SAFETY AUDIT

STAGE 1/2

Wadsworth Gardens PROWs, Cleckheaton

ON BEHALF OF
BARRATT & DAVID WILSON HOMES

PROBLEM LOCATION PLAN 1

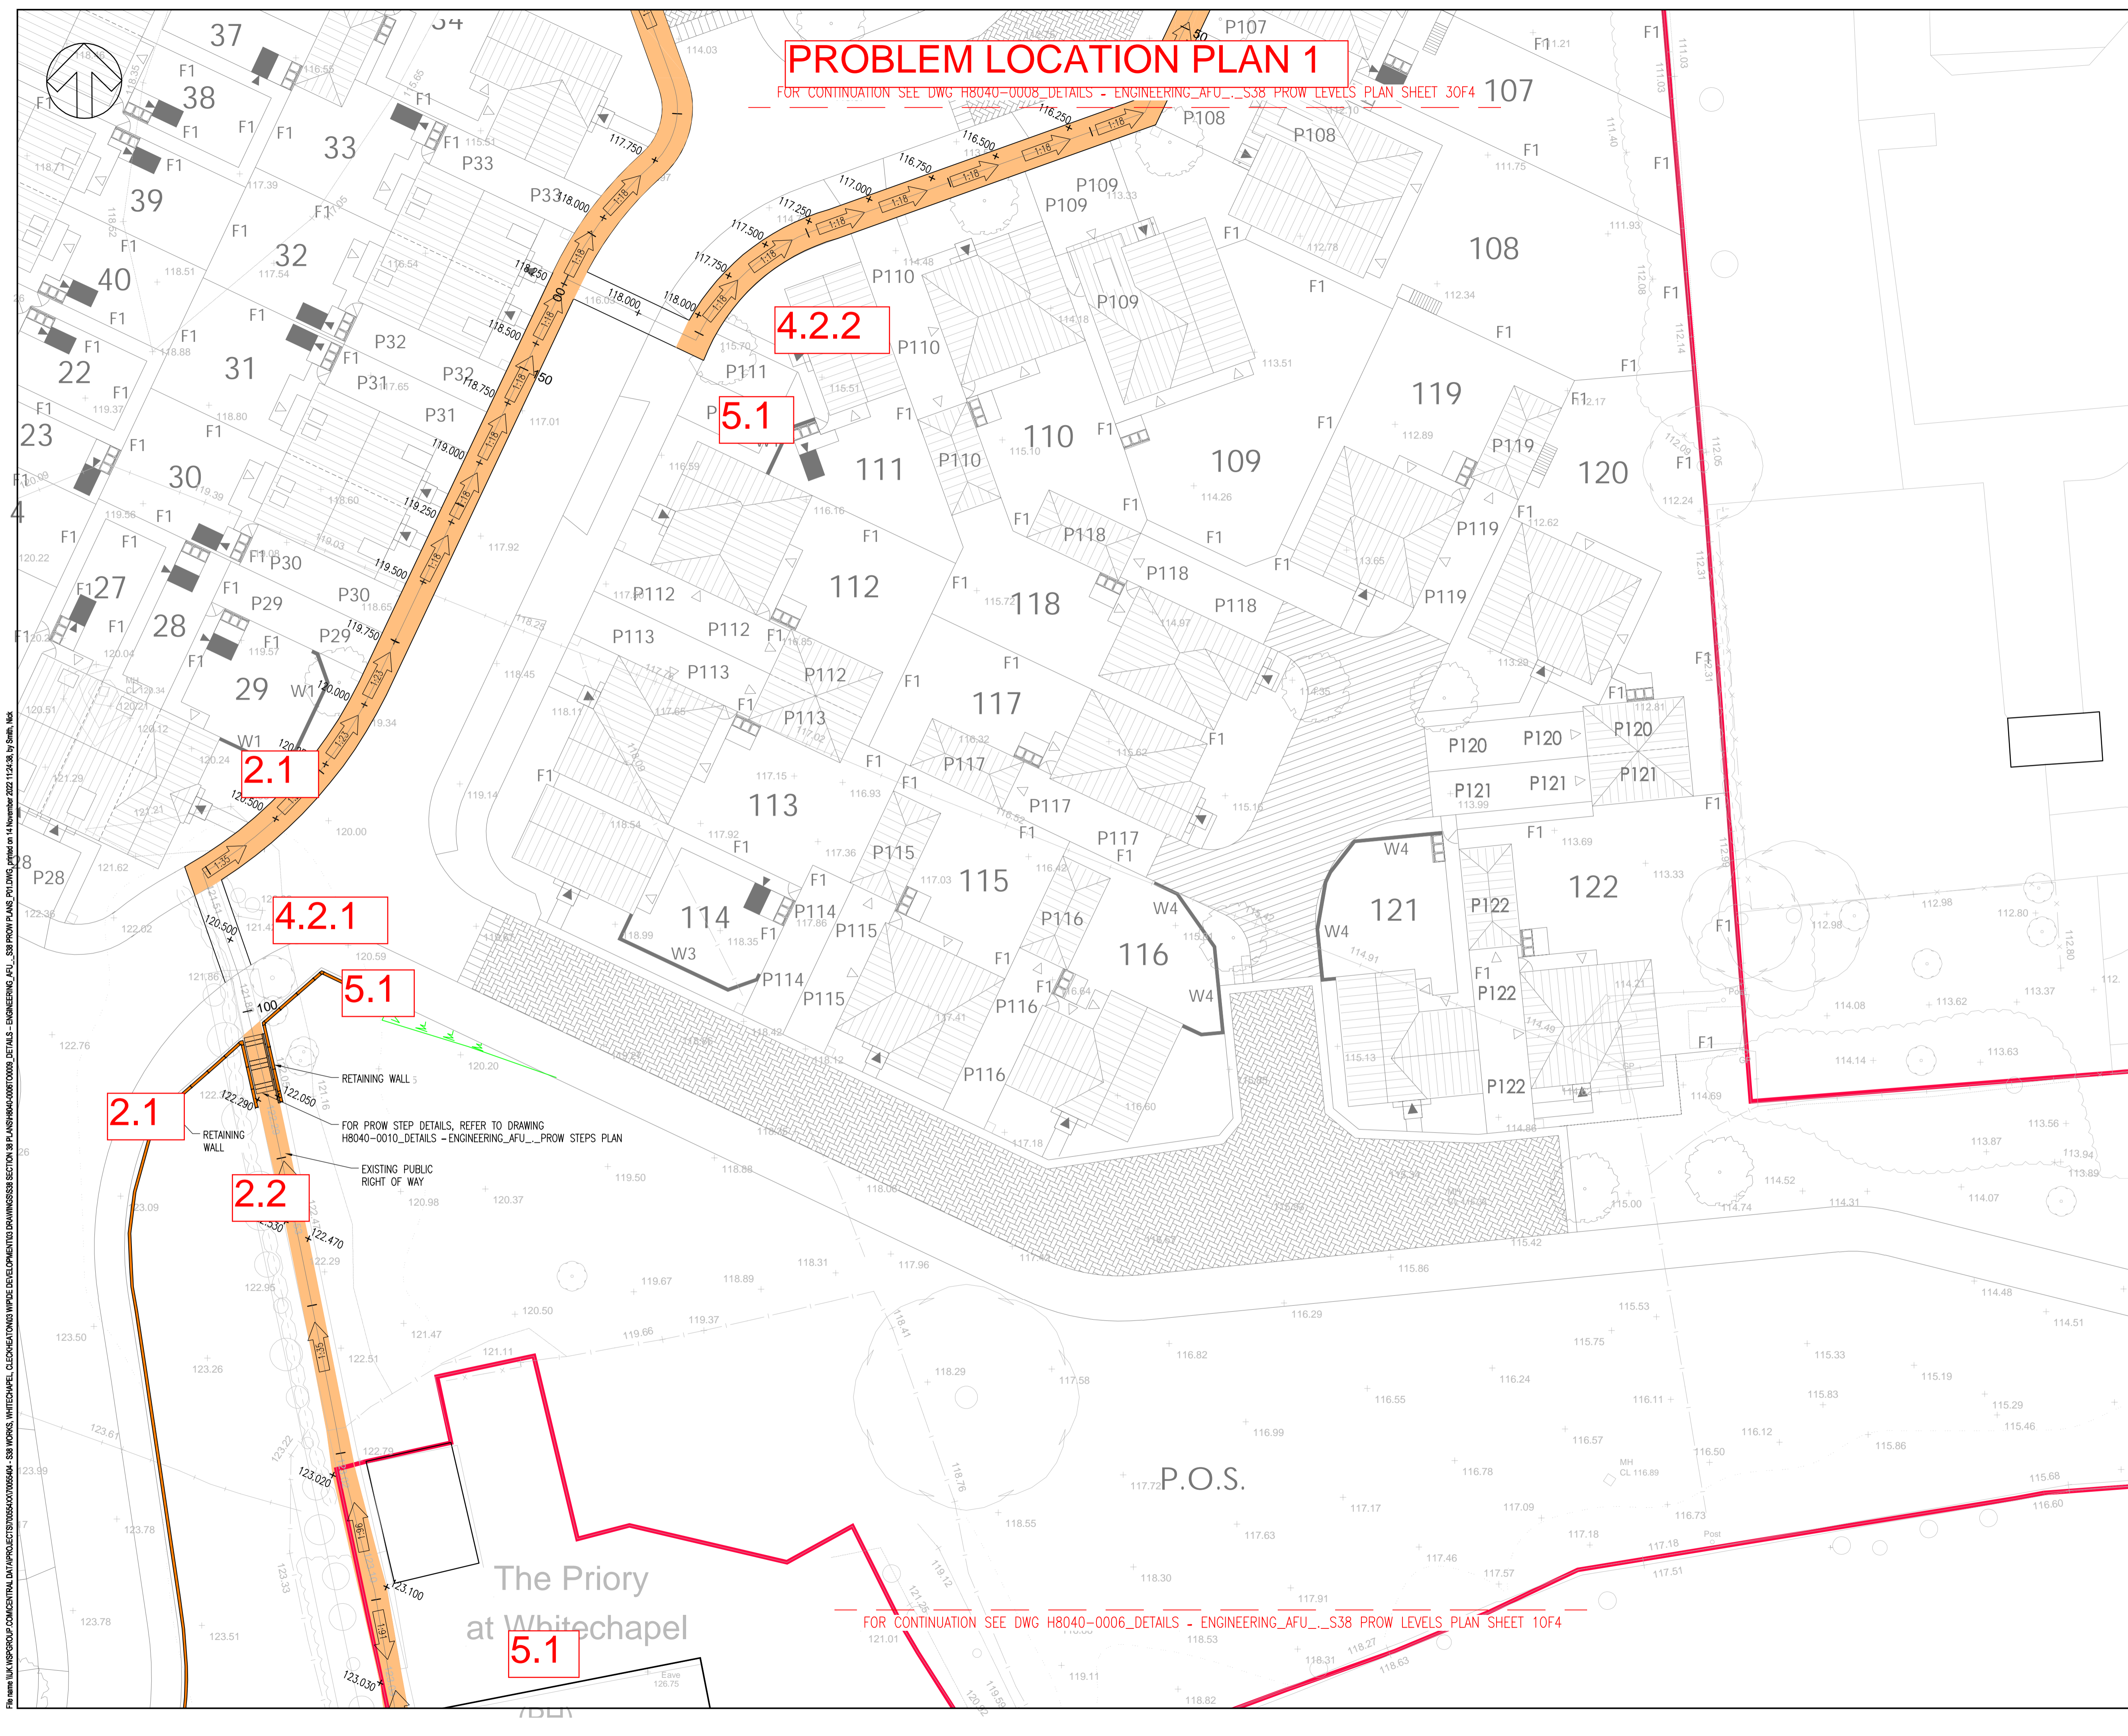
2.1 Problem: Visibility for pedestrians crossing Road 1

Summary: *No visibility splays shown on the drawings for pedestrians crossing Road 1 adjacent to the top of the proposed steps in the new PROW near plots 28 / 29. It is unclear whether adjacent boundary treatments / retaining wall parapet would obstruct splays placing pedestrians in danger.*

No visibility splays are shown on the drawings for pedestrians using the proposed crossing location for the new PROW adjacent to the top of the steps in the latter near plots 28 / 29. Pedestrians crossing from south to north after emerging from the steps would have to look left over the parapet wall to view oncoming traffic. It is not clear whether the height of this wall relative to the vertical alignment of Road 1 would prevent a pedestrian from observing an approaching vehicle and vice versa.

For pedestrians crossing at the same location but from north to south, it is not clear whether there is sufficient visibility afforded to a pedestrian within the proposed highway of vehicles approaching from the north and vice versa without crossing in to private garden areas where planting might obstruct their view.

Failure to provide adequate visibility for pedestrians to judge whether it is safe to cross a carriageway could lead to collisions.

2.3 Problem: Design of Proposed Steps

Summary: *The design of the proposed steps does not fully address usage by vulnerable users with mobility difficulties. There are no measures proposed for aiding people with vision deficiencies. These issues could result in potential injuries to such users.*

The design of the proposed steps has risers of 170mm and tread depth (going) of 300mm with landings of 1000mm. The steps are shown as being 1200mm wide and will have a total rise of 1.53m. There is no tactile paving shown on the drawings at the top or bottom of the proposed steps.

Current guidance in CD 143 indicates that risers should be a maximum of 50mm whilst the treads should be a minimum of 280mm and 350mm with landings of 1800mm. These are guidance figures for such measures on Trunk Roads which none of the roads in the area are classified as such. Other advice that is available on such matters (in relation to accessibility under the Disability Discrimination Act (DDA) and access to commercial buildings and advice of the Sensory Trust) suggests that risers should be provided between 100mm and 150mm whilst the treads should be between 280mm and 350mm with landings of at least 1200mm.

Therefore, the steps as proposed do not completely comply with current guidance for users with mobility difficulties or vision deficiencies which could result in falls and stumbling of users.

4.2.1 Problem: Location of crossing point of Road 1

Summary: *The drawings show that the proposed dropped crossings / tactile paving are offset from the direct line of the route for pedestrians emerging from the top of the steps. The location of this crossing point is not clear to approaching drivers. These factors could result in collisions with pedestrians crossing at less safe locations.*

The drawings provided show that the proposed dropped crossings / tactile paving located adjacent to the top of the steps on the PROW opposite plots 28 / 29 are offset from the direct line of the route for pedestrians emerging from the top of the steps. No explanation for this offset has been provided.

The location of this crossing point on a tight bend is not readily apparent to approaching drivers and the latter might be taken by surprise if say a group of walkers suddenly emerged from the steps and needed to cross the road.

4.2.2 Problem: Location of crossing point of Road 1

Summary: *The proposals indicate that part of the diverted PROW will cross Road 1 in the vicinity of plot 111. This uses the vehicle crossover to the drive to plot 111 and there is no dropped kerb or tactile paving on the opposite footway. Failure to indicate a safe crossing point for pedestrians could lead them to use less safe locations.*

The drawings indicate that part of the diverted PROW will cross Road 1 in the vicinity of plot 111 using the vehicle crossover to its driveway. The Audit Team has noted that there is no dropped kerb or tactile paving on the opposite footway in this location.

Whilst the potential for a crossing pedestrian being in conflict with a vehicle using the driveway to plot 111 is small, the location is not ideal and would make it difficult to provide tactile paving in that location. The lack of a dropped crossing and tactile paving on the opposite footway would result in people in wheelchairs or with perambulators having to bump over full height kerbing.

5.1 Problem: Lack of signage details provided

The drawings do not show the provision of PROW signage, so the Audit team are unable to review but have made some recommendations.

It is recommended that the drawings be amended to show what visibility can be achieved at this crossing point for pedestrians and boundaries / treatments be designed so as to avoid them being obstructed.

It is recommended that the drawings be amended to provide risers of no more than 150mm, treads of at least 300mm (already shown) and the landings be increased to at least 1200mm. The provision of corduroy paving at the top and bottom of the steps is also recommended.

It is recommended that the drawings be amended to revise the position of the dropped crossings / tactile paving to be in line with the proposed route. The presence of the crossing point is recommended to be highlighted by either the provision of a different colour / texture of road surface and / or placed on a flat top speed hump.

It is recommended that the design team review the location of this crossing point and place it away from driveways so as to allow the provision of dropped crossings and tactile paving.

- 1 A PROW signage scheme shall be prepared and be subject to review by the Audit Team.
- 2 The signage scheme shall include direction signs from Whitechapel Road to the north eastern end of the development site and at any points in between where a route decision has to be made.
- 3 Given the presence of steps proposed on part of the PROW route, the alternative route for people in wheelchairs and with perambulators should be sign posted on / along Whitechapel Road and Road 1.
- 4 The designated crossing points where PROW users cross the new estate roads shall be sign posted / clearly marked and / or warning signage provided as necessary.

PROBLEM LOCATION PLAN 2

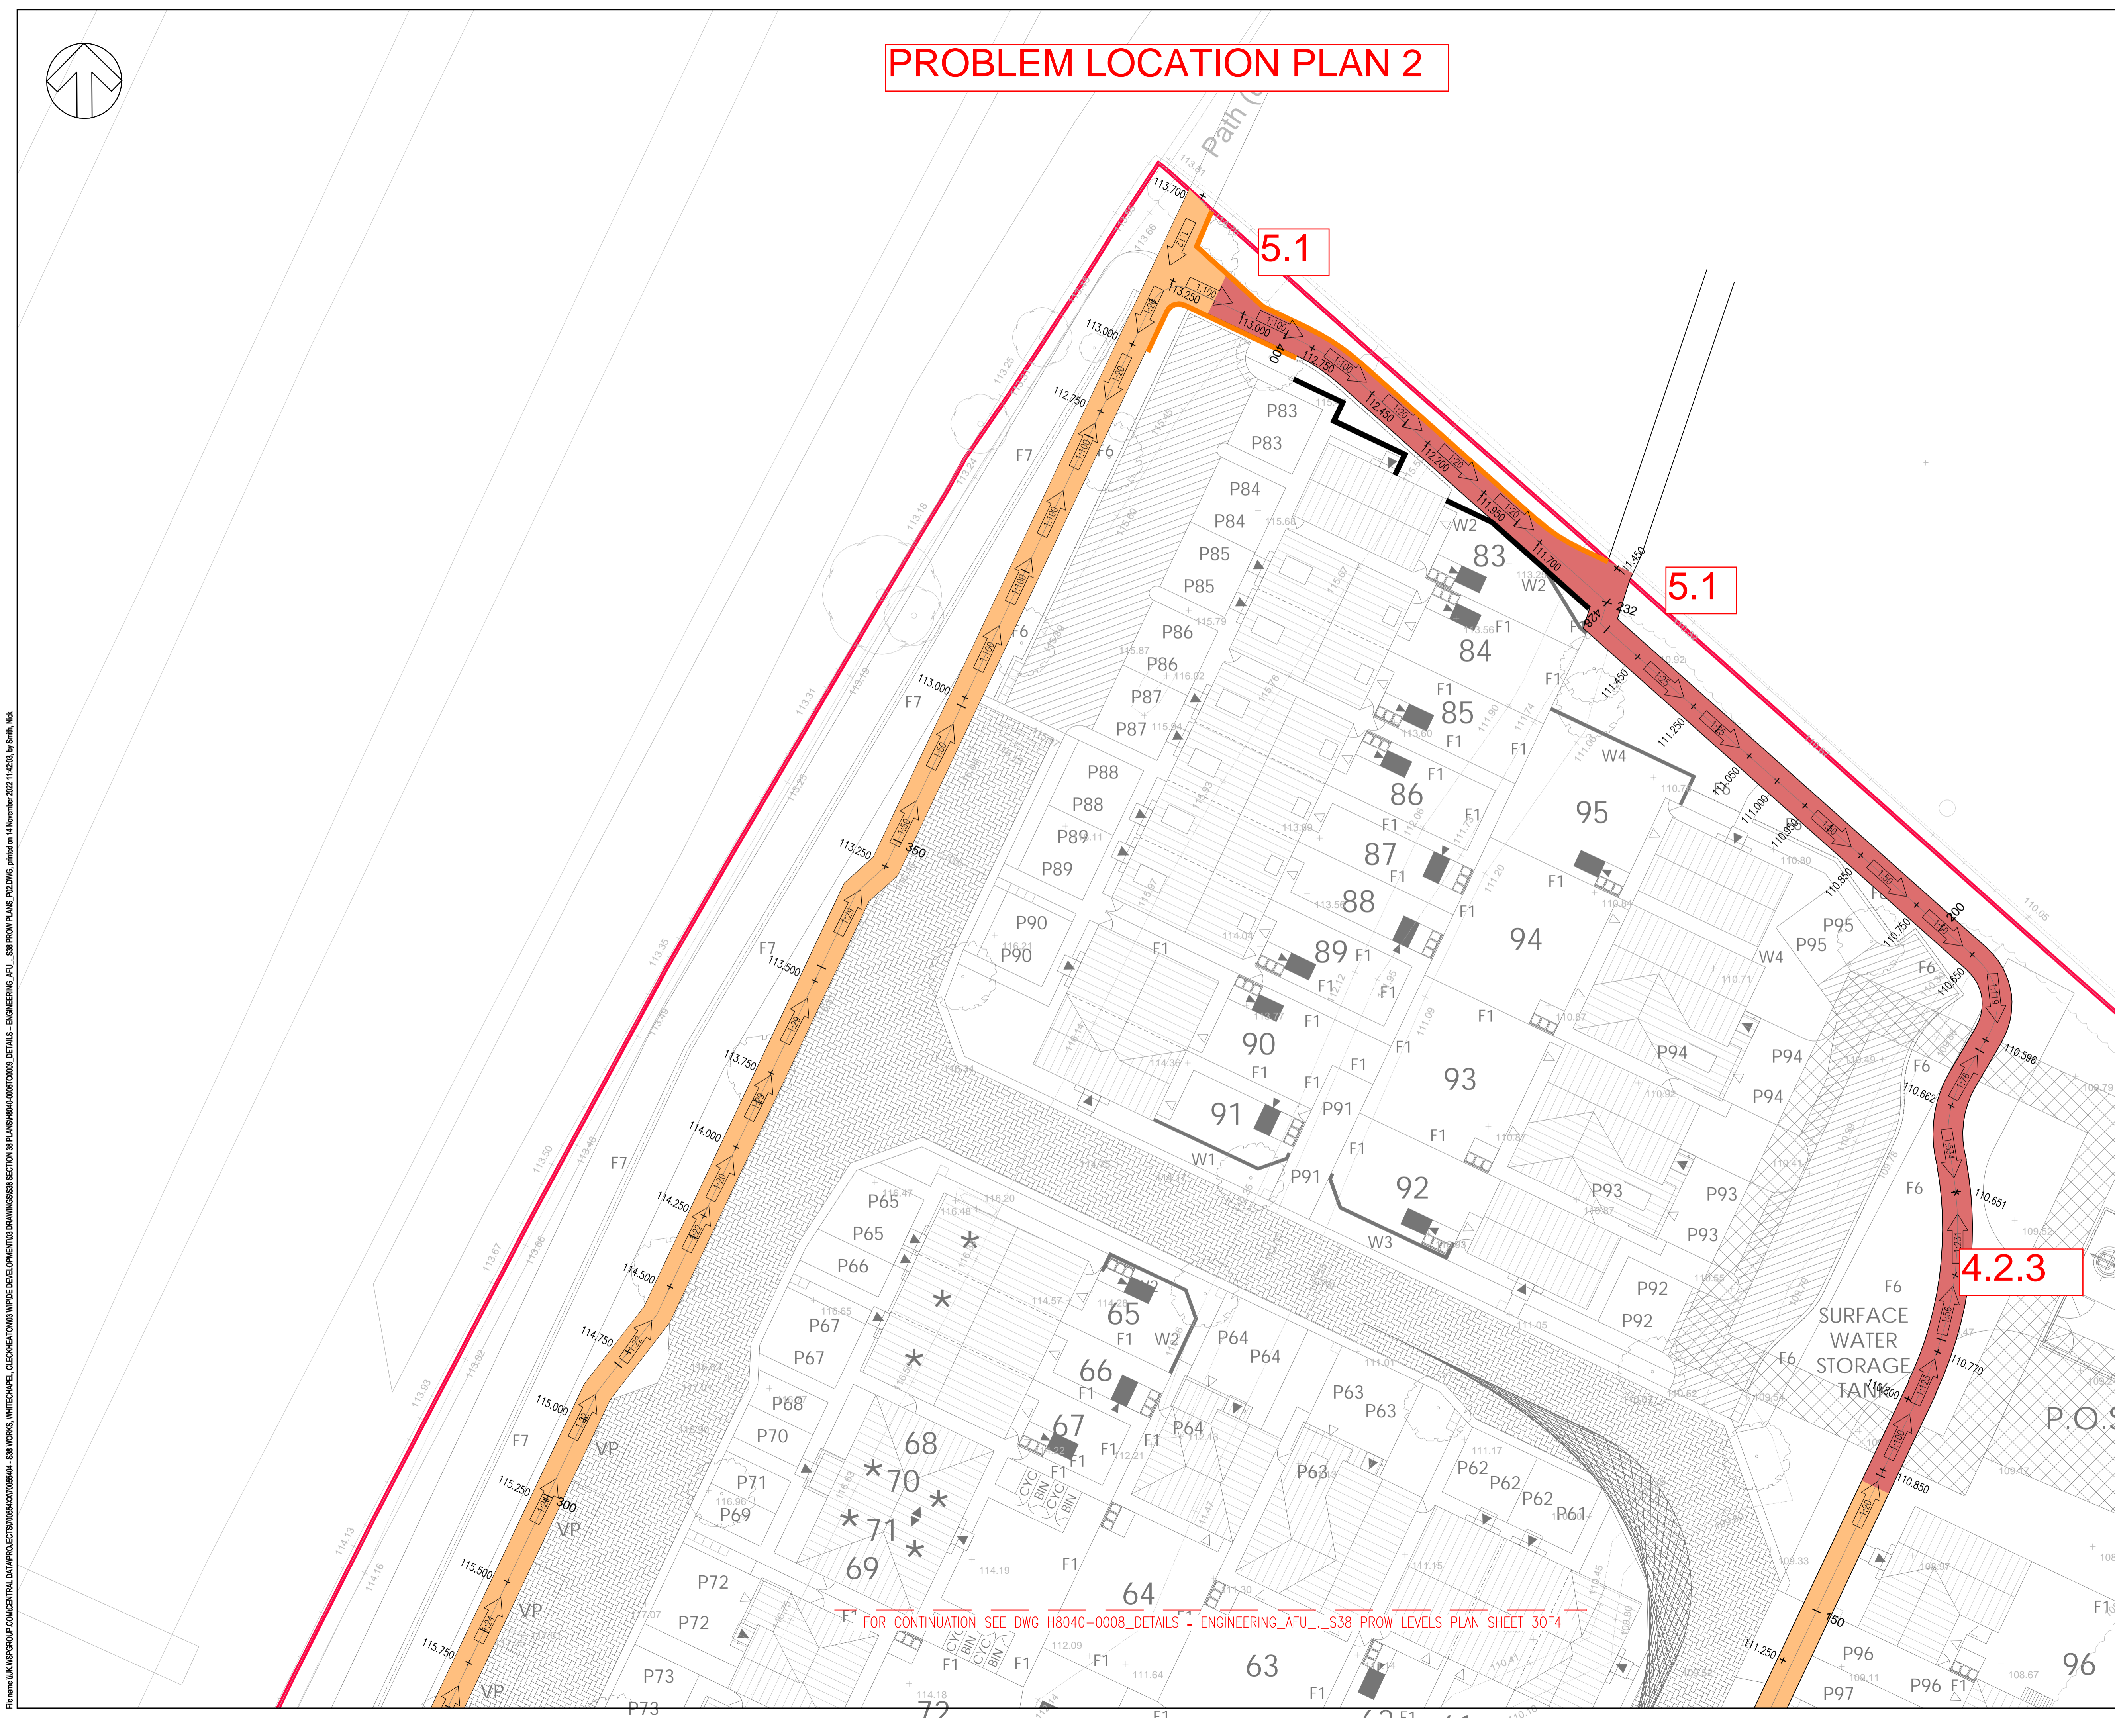
4.2.3 Problem: PROW crosses private access road of unknown construction

Summary: *The drawings indicate the route of the PROW will cross the private access road serving the pumping station. No details of the construction of this access road are provided and the PROW would be overrun by maintenance vehicles which could result in its failure creating trip hazards.*

The drawings provided to the Audit Team indicate that the route of the PROW at the north east end of Road 1 (near plot 96) will then continue across the private access road serving the pumping station. No details of the construction specification of this access road are provided.

The drawings show that the PROW in the above location would be to a loose stone footpath specification. As this will be overrun by maintenance vehicles, over a period of time this construction might fail and so create trip hazards for users.

It is recommended that the specification for the PROW in the above location be upgraded so as to cater for overrun by maintenance vehicles.
